Cefn Coed Colliery Museum
Renovation of two Grade II* Listed headgear frames

Building at base of Headframe 1
Current condition and works proposed

For Listed Building Consent CD-V-C8458.60

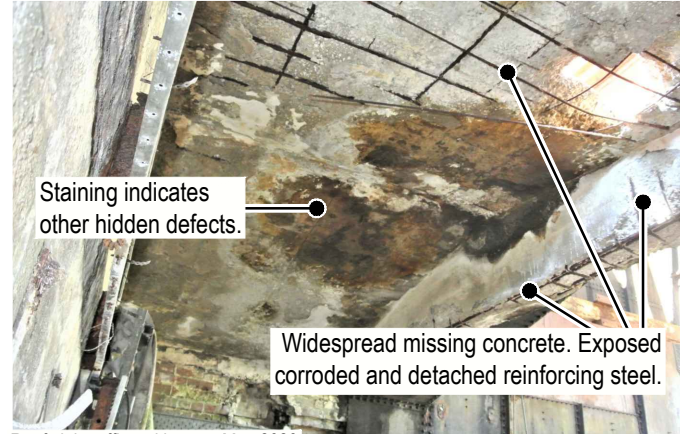
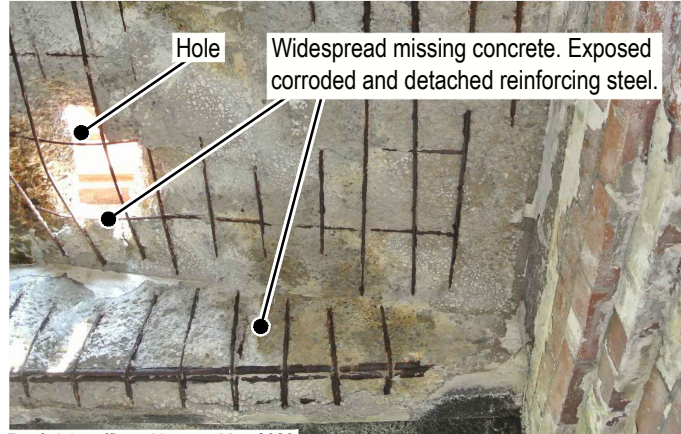
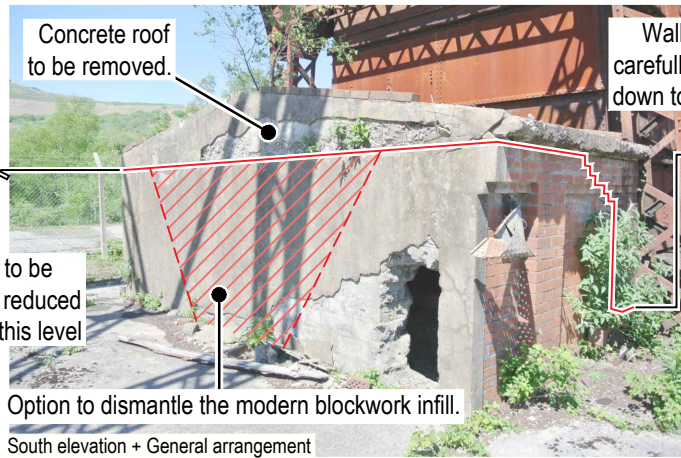
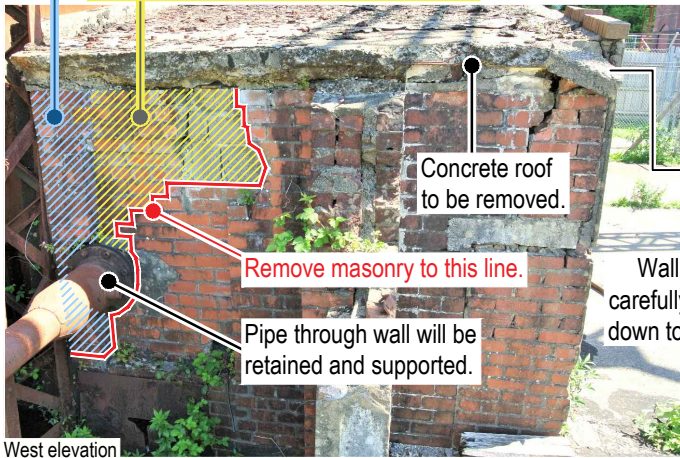
Remove this masonry to improve access for repairs and maintenance.

This masonry likely to become unstable.

Remove this masonry to improve access for repairs and maintenance.

This masonry likely to become unstable.

Significant deterioration of the concrete roof has occurred since the survey in April 2018 (and the basis for the Listed Building Consent granted in July 2018): holes have appeared through the slab; widespread loss of concrete across the underside of the slab and beam faces, exposing corroded reinforcing steel. Consequently, it is no longer feasible to repair the roof nor ensure it can safely remain in place whilst adjacent repairs are undertaken.

The concrete roof is of limited architectural or historic significance. It is proposed to remove the concrete roof entirely (it will not be replaced). The adjoining steel canopy will remain and be refurbished. This follows the profile of the roof and, together with the wall remains (see text opposite), will retain sufficient evidence of the form of the building.

As the roof is now to be removed, the modification to the wall can be adjusted to improve the access further: the extents of this is shown on the annotated photographs above (hatched light blue). Consequently, small areas of wall (hatched yellow) have the potential to become unstable, primarily due to the corbel detail or apertures formed crudely in the wall: it is proposed to dismantle these areas to safeguard the stability of the majority of the walls. The pipe which passes through the wall will be retained and supported in-situ.
